**PLANNING COMMISSION
 STAFF REPORT
 AGENDA ITEM NO. 5A
 November 3, 2015**

1. Address: 841 San Bruno Avenue West
2. Assessor's Parcel No: 020-072-290 and 020-072-330
3. Zoning District: A-R (Administrative and Research)
4. General Plan Classification: Transit Oriented Development
5. Transit Corridors Plan: El Camino Character Area

Request to amend the Zoning Code to change from Administrative and Research (A-R) District to Planned Development District (P-D); a Planned Development Permit (P-D-P); an Architectural Review Permit, and a Lot Line Adjustment for the construction of a new 15,233 square foot medical office building with 43 parking spaces, per Chapters 12.136, 12.108, 12.52, 12.96.020 and 12.96.190 of the San Bruno Municipal Code, and an Initial Study/Environmental Checklist in accordance to the CEQA Guidelines Section 15168. Charles Smyth, Market Street Development, LLC (Property Owner) **ZA-15-001, PDP15-003, AR-15-005.**

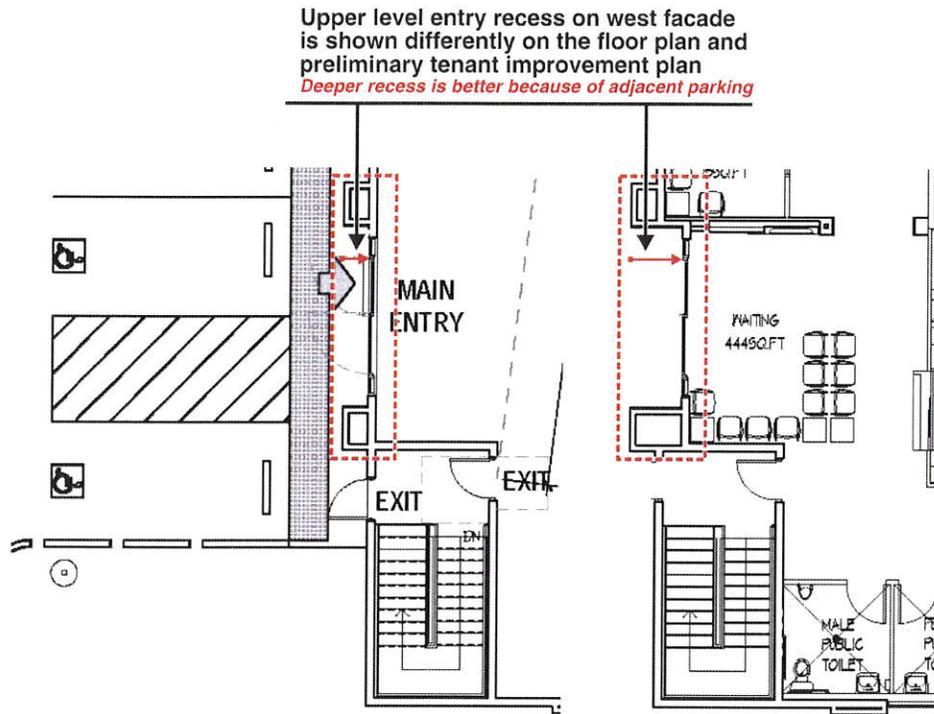
2. The floor plan for the east entry at the upper level is shown with different recessed depths for the entry doors on the Upper Level Floor Plan and the Preliminary Tenant Plan.

Recommendation: Modify the Upper Floor Plan to provide the greater depth of entry at the recess. This would result in a stronger entry, and would assist slightly in addressing the concern raised in the first comment #3 bullet below.

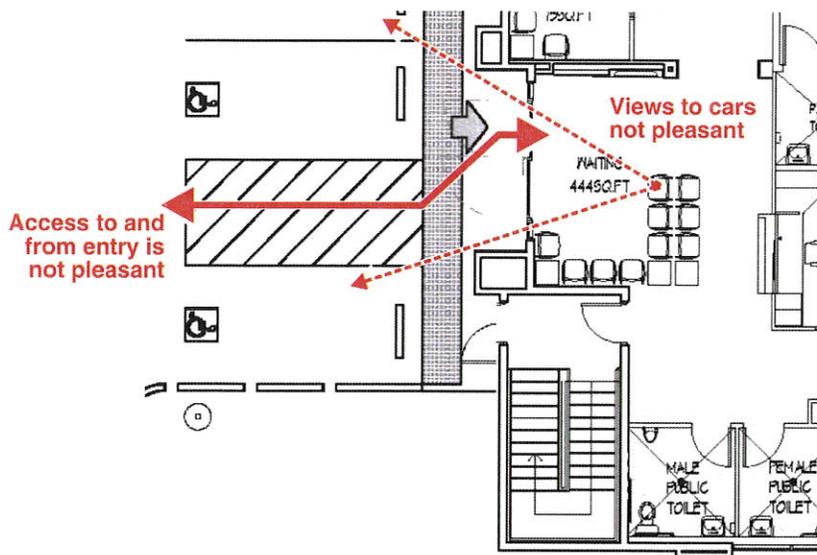
3. The east entry is quite awkward for the following two reasons.

- The pedestrian path linking the entry and the parking lot is not very pleasant with very close proximity to parked cars.
- Patients in the waiting room would have only a view of the fronts of parked cars.

Recommendation: Consider a slightly smaller building to allow either a landscaped buffer between the building and the parking lot or the elimination of some parking spaces to provide a landscaped area were some parking is currently located.
